Report to the Sydney Eastern City Planning Panel on an application for a site compatibility certificate under State Environmental Planning Policy (Housing for Seniors or People with a Disability) 2004

SITE: 11-19 Frenchmans Road, Randwick, comprising three parcels of land legally described as Lots 3 and 4 in DP 13779 and Lot 10 in DP 845575.

APPLICANT: Higgins Planning Pty Ltd on behalf of Frenchmans Lodge Properties Pty Ltd. The application form (**Attachment A1**) for a site compatibility certificate (SCC) was submitted to the Department of Planning, Industry and Environment (the Department) on 24 November 2020.

Figure 5 – Site plan (source: boffa robertson group)

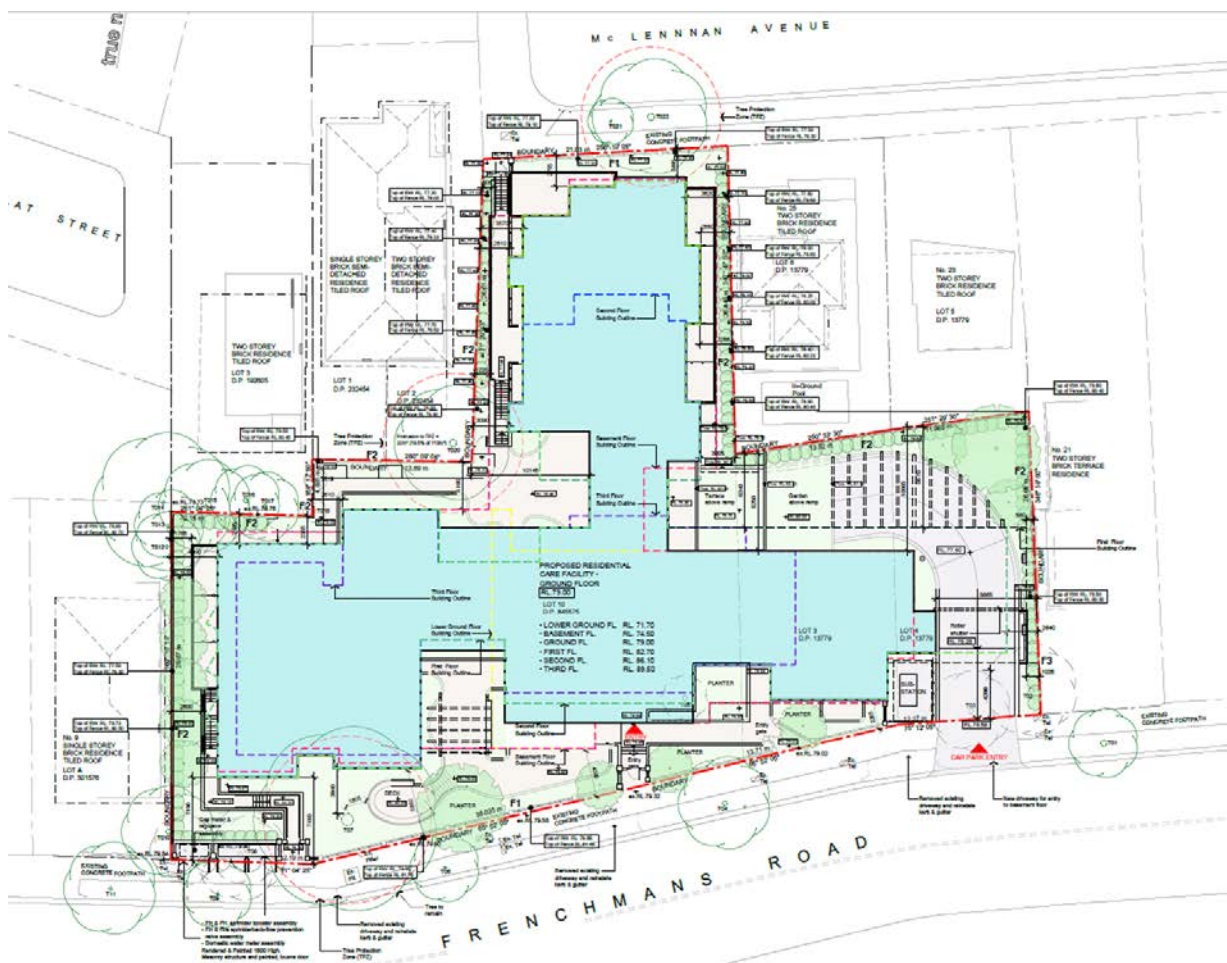
An extract of the site plan and indicative building sections are provided at **Figures 5 to 8** below.

Figure 13 – Extract of the ground floor plan of the building (source: boffa robertson group)

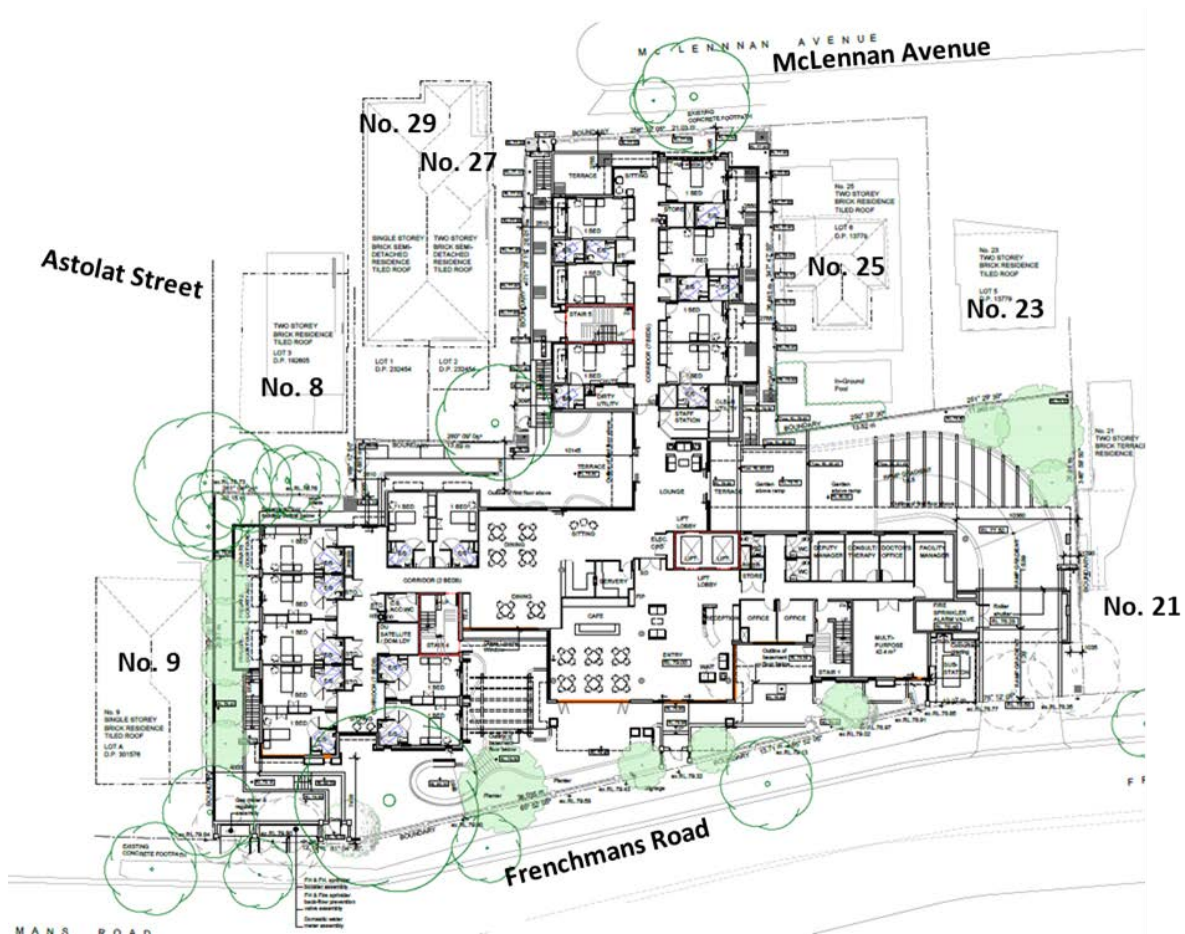
The indicative design is setback from existing surrounding development by:

- between 1.8m and 4m to 9 Frenchmans Road;
- between 0.58m and 10.36m to 21 Frenchmans Road;
- between 2.5m and 3.65m (eastern boundary) and greater than 6.34m (northern boundary) to 25 McLennan Avenue;
- greater than 8.66m to 23 McLennan Avenue, and
- 2.51m to 10.15m to 27 McLennan Avenue (western boundary) (see **Figure 13** below).

When considering this existing and future context, the scale of the indicative design is considered to be compatible with the Frenchmans Road frontage of the site. However, the three to four-storey scale of the development is not compatible with the existing McLennan Avenue frontage of the site and its interface with the side and rear of 23, 25, 27 and 29 McLennan Avenue. It is acknowledged that the amended SCC application further setback the upper levels of the northern wing away from McLennan Avenue.

Despite the stepped form, the indicative design remains highly perceptible at the current proposed scale to McLennan Avenue. The non-compliance with the Randwick LEP 2012 with regard to height also suggests this element is not compatible with the planned future context of this area.

The proposal should be refined through the DA process to provide a more compatible scale to McLennan Avenue and the immediate neighbours. Opportunities should be considered to increase the side setbacks, and setback at the rear boundary to McLennan Avenue to be more compatible with the neighbouring properties. This would allow opportunities for further landscape planting to soften and screen the development and be more sympathetic to the residential streetscape and the adjoining heritage items at 23 and 25 McLennan Avenue. Further modulation and articulation of the built form should be explored to reduce its visual scale.

- Bulk and scale – the proposal should be refined through the DA process to provide a more compatible scale to McLennan Avenue and the adjoining properties, including the local heritage items at 23 and 25 McLennan Avenue. This includes consideration of increased setbacks to McLennan Avenue and the side boundaries, and further refinements to the built form.
- Privacy – the proposed development should consider the inclusion of privacy control measures to mitigate any privacy impacts on the neighbouring dwellings.
- Landscaping – the proposed development should consider an increase in the provision of landscaped areas (as defined in the Seniors Housing SEPP) as well as deep soil landscaping along the side and rear boundary setbacks.

Figure 16 – Extract of winter solstice overshadowing plans (*source: boffa robertson group*)

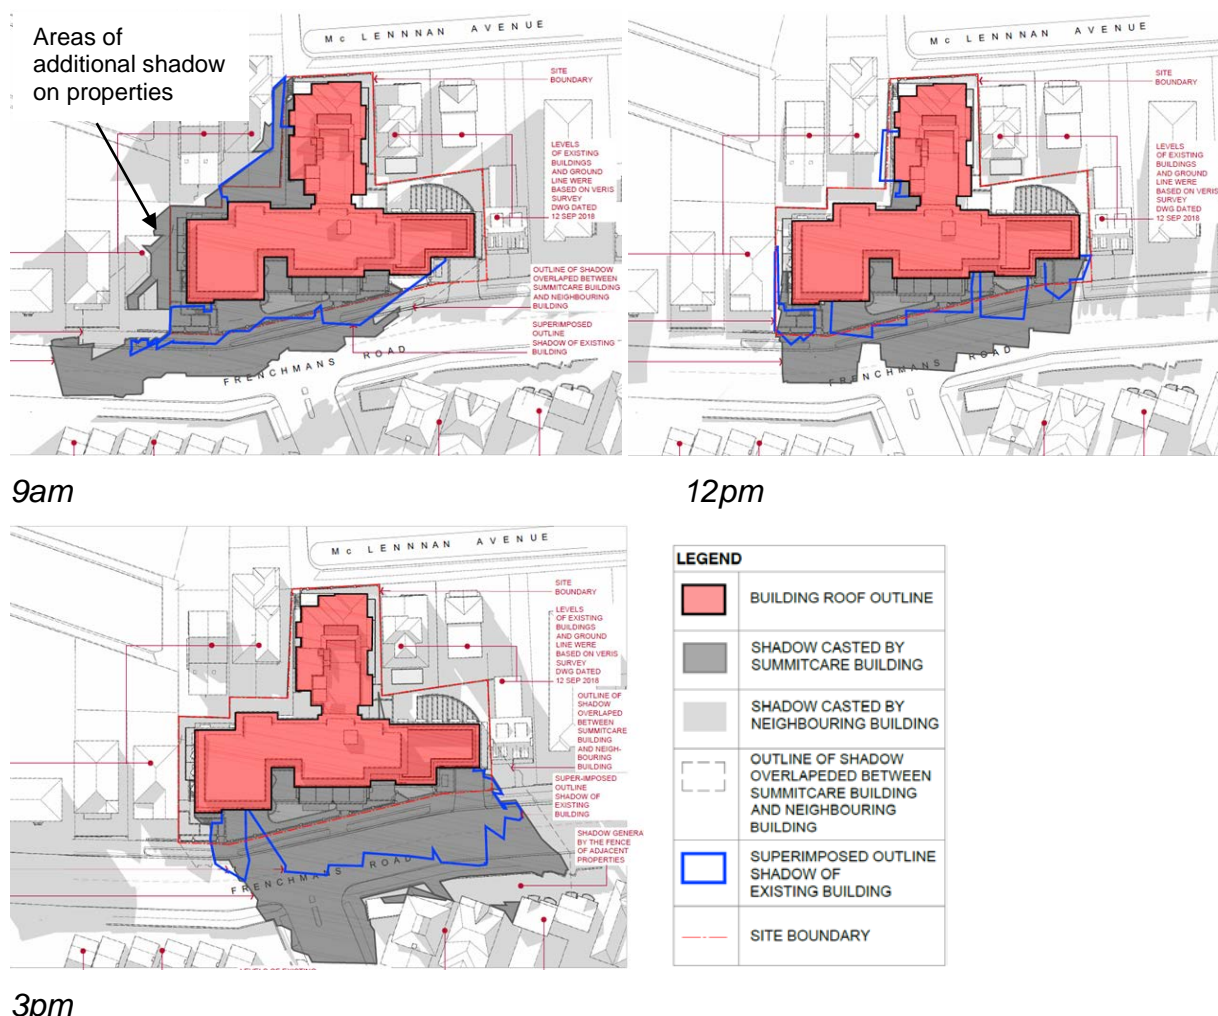
Shadow diagrams have been prepared for the SCC application (see **Attachment A9**) comparing the impact of the existing and indicative development on the site during the winter solstice (21 June). The shadow cast by the indicative development largely falls within existing areas of shadow or on the local road network, including to the adjoining heritage items at 23 and 25 McLennan Avenue.

There will be additional shadow cast on the dwellings at 7 and 9 Frenchmans Road in the morning (8am to midday) within the rear open space area and the east facing windows. These dwellings will be unaffected by the development from midday.

The shadow modelling indicates that the concept development will not result in any surrounding dwelling and primary open space area receiving less than 3 hours of sunlight at midwinter. Refer to **Figure 16** below.

It is noted the Applicant did not prepare updated shadow diagrams to reflect the latest changes to the roof and lowered front parapet, however there would likely be a small improvement to the impact.
